Final Environmental Impact Report Volume IV - Response to Comments/Errata

South Shores Church Master Plan City of Dana Point

SCH No. 2009041129

**RESPONSE TO COMMENTS
AND ERRATA**

Salt Creek Corridor Trail storm drain intake system perimeter near Pointe Monarch.

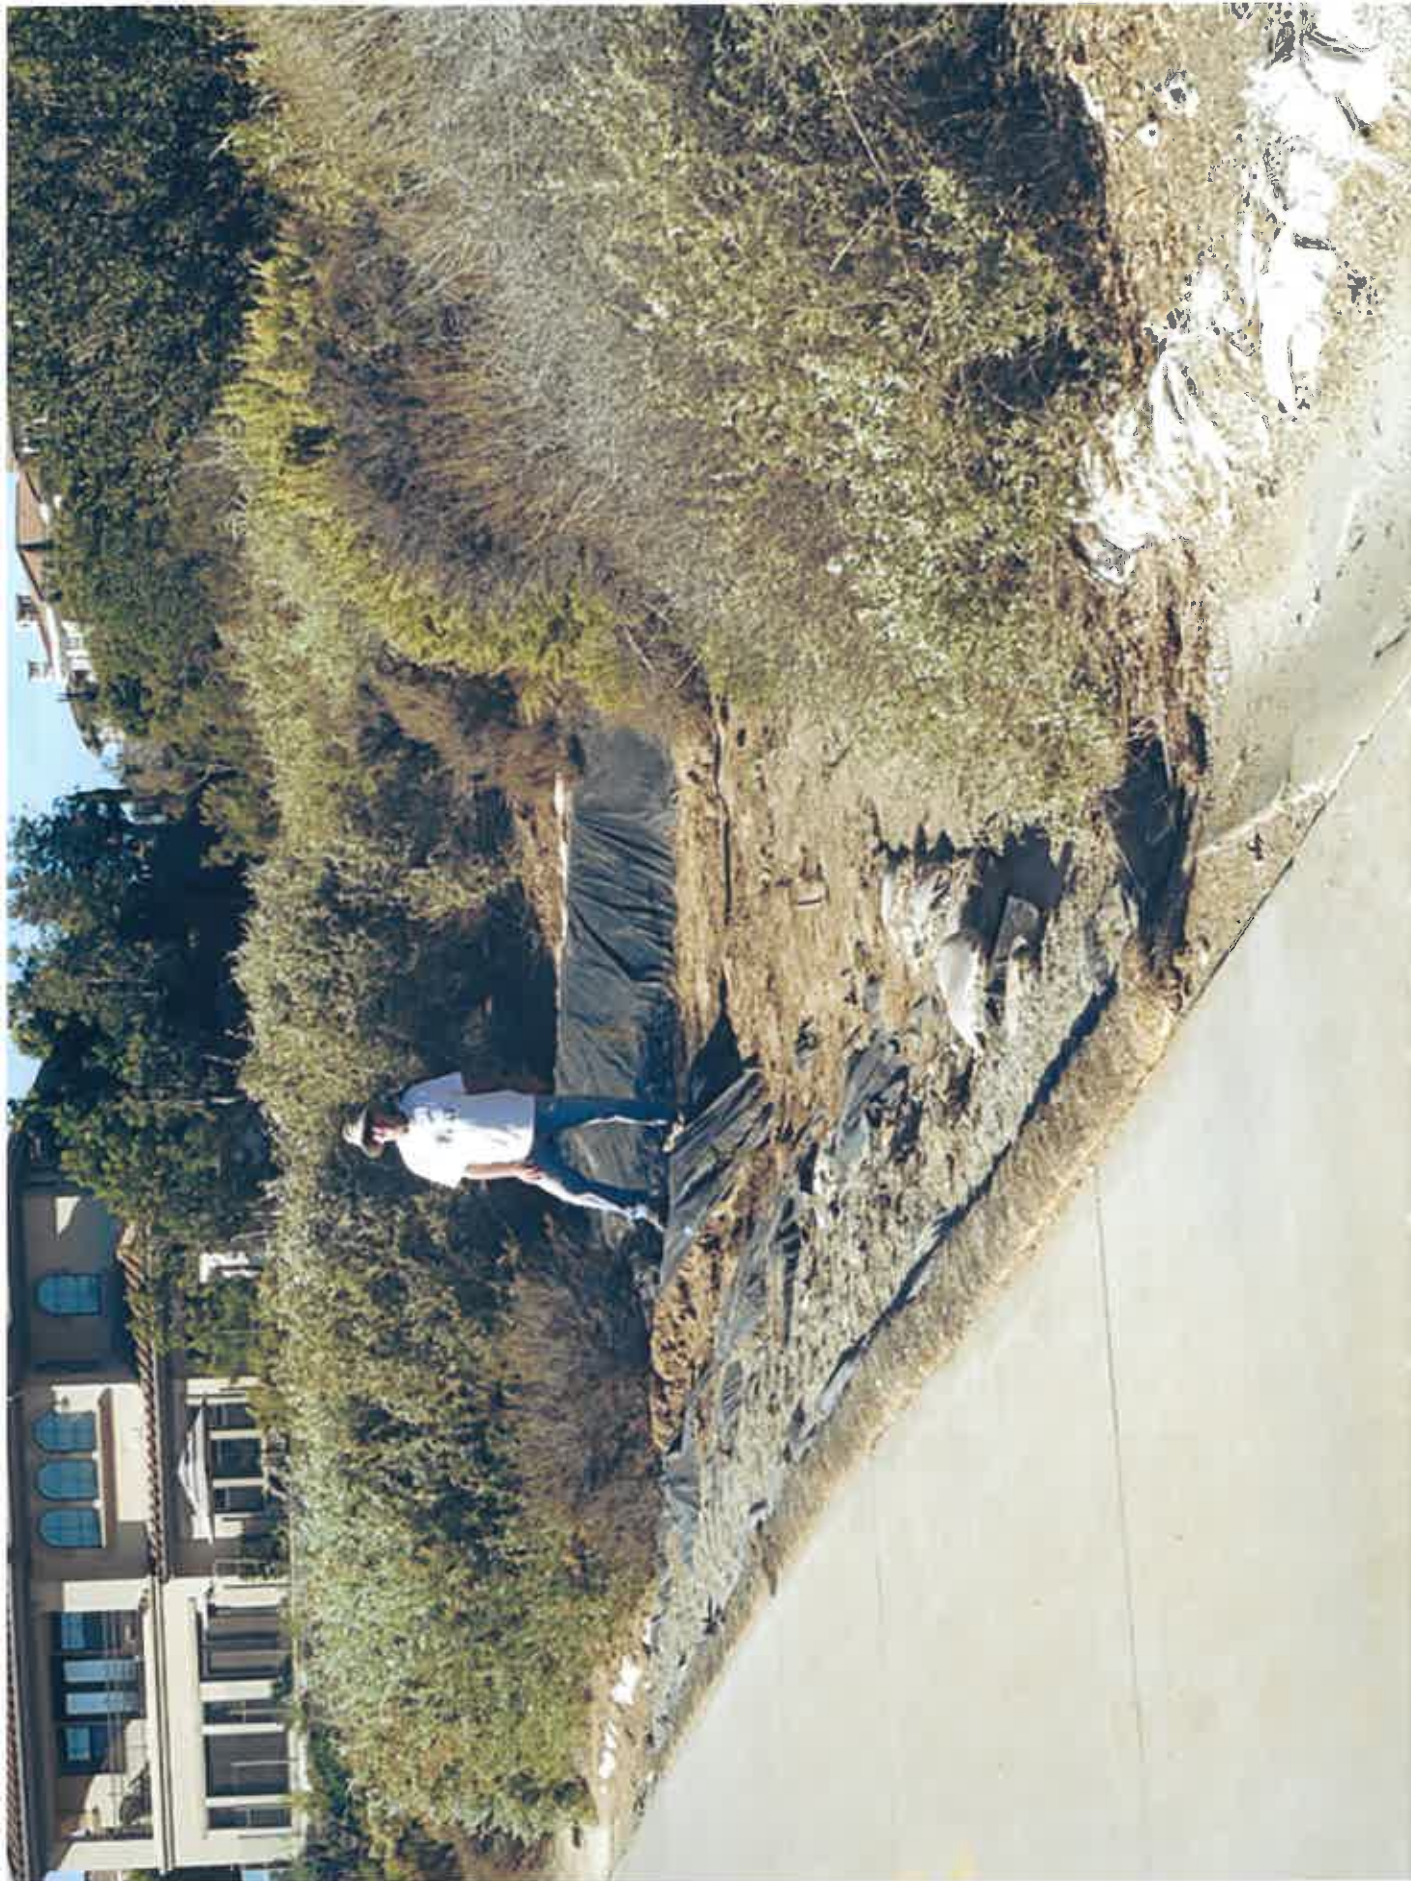
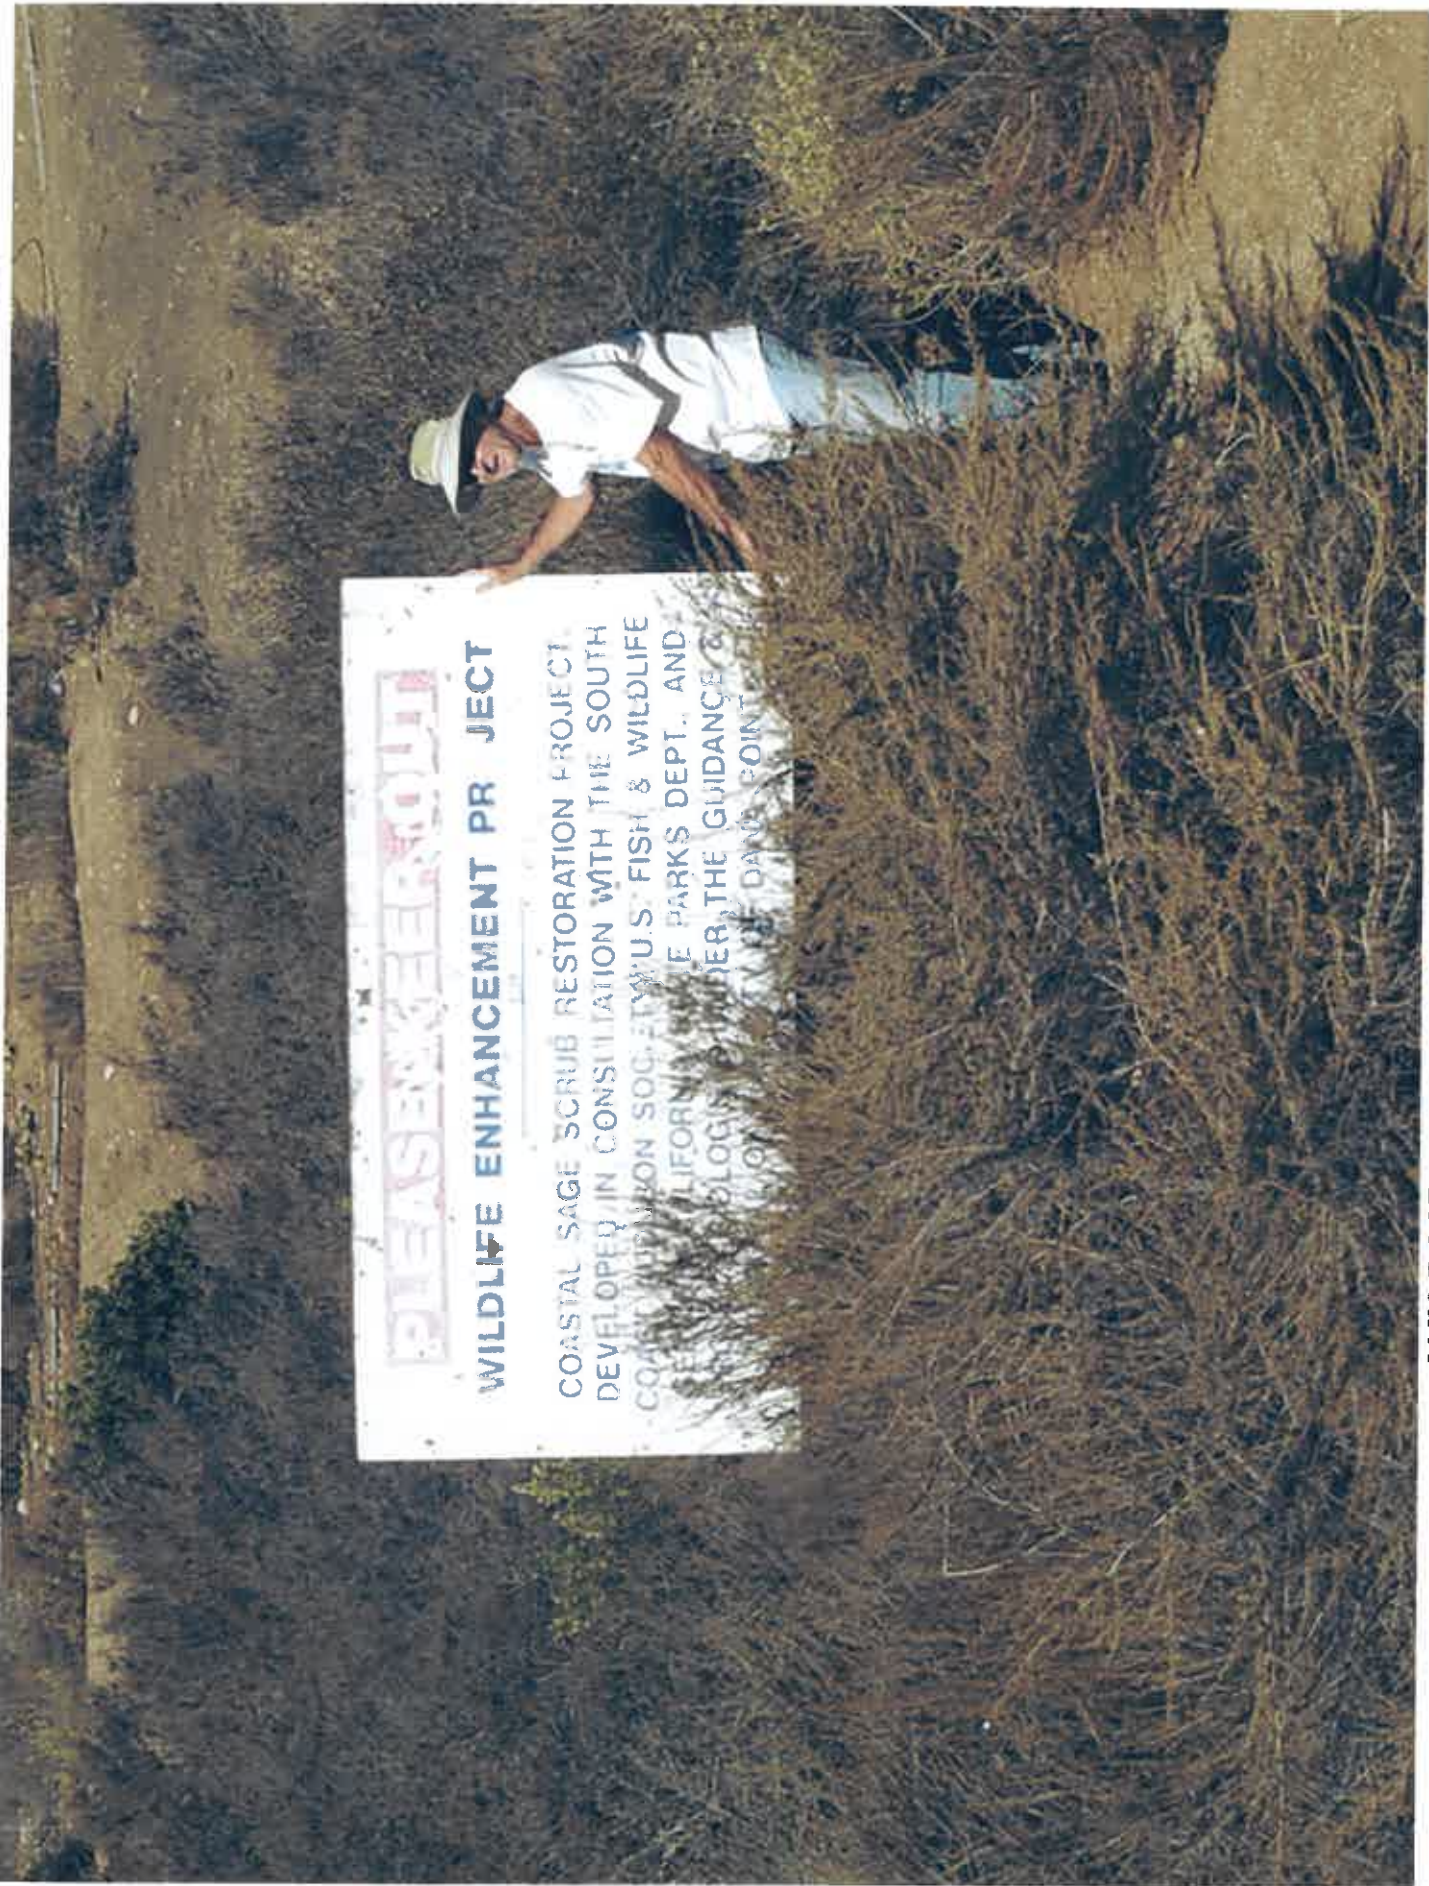
I-12-14

WILDLIFE ENHANCEMENT PROJECT sign:
Note denuded, heavily eroded meadow above

Left Turn Out Median Shelter

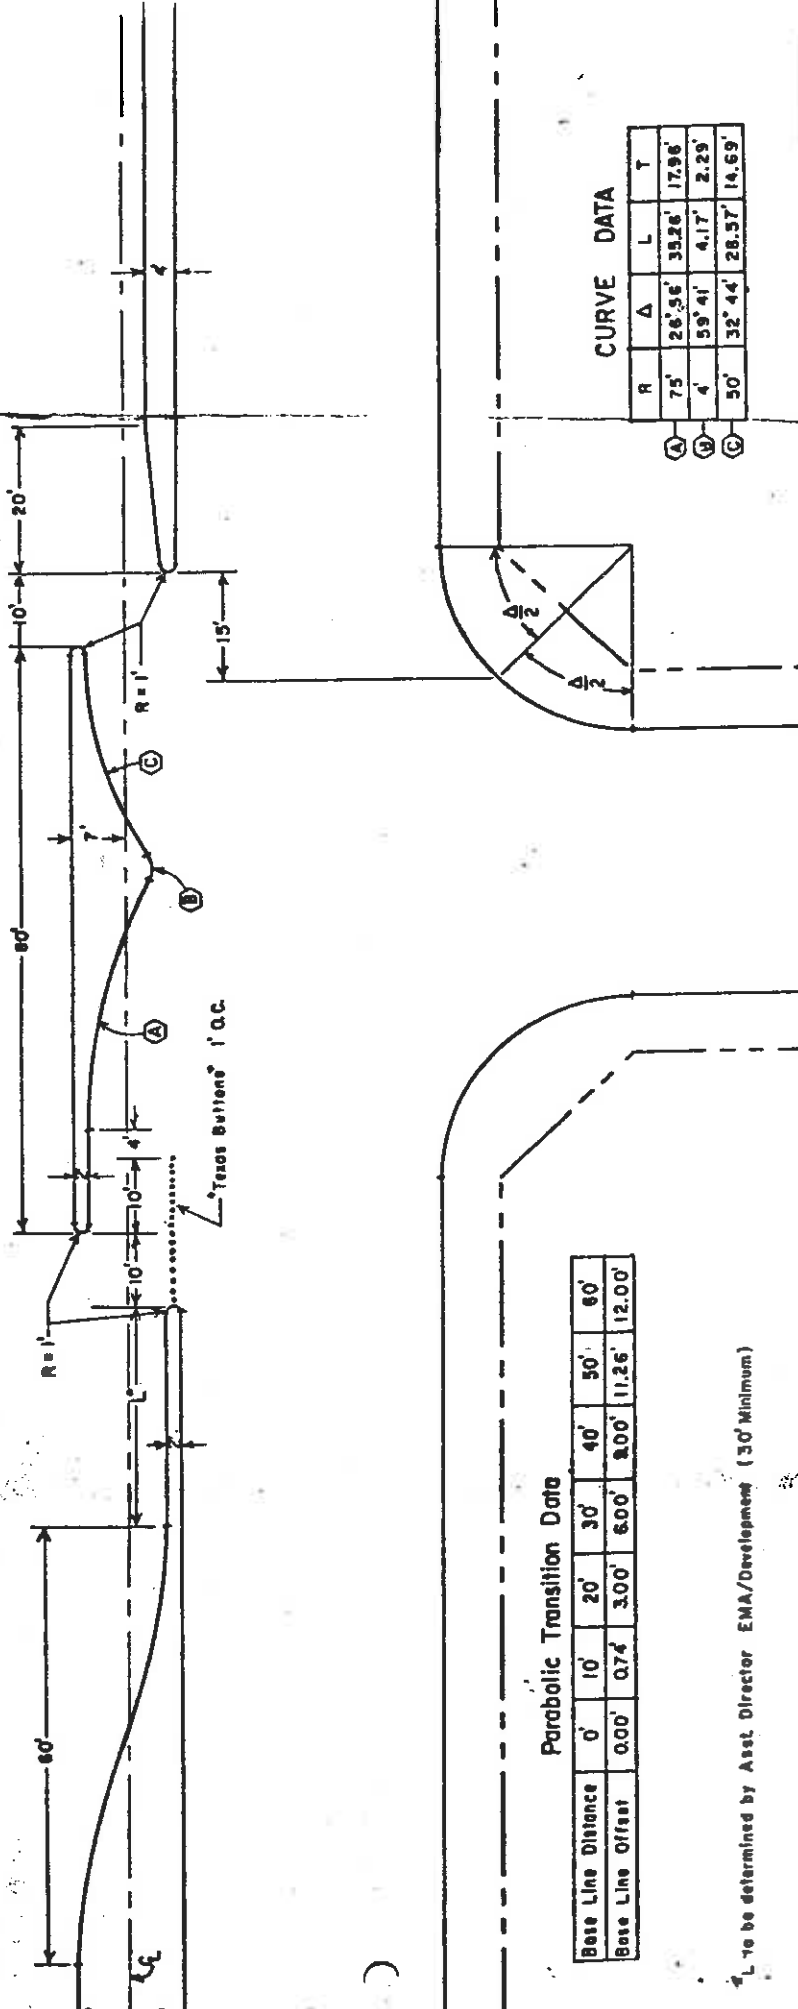
Encl: Left Turn Out Median Shelter Plan
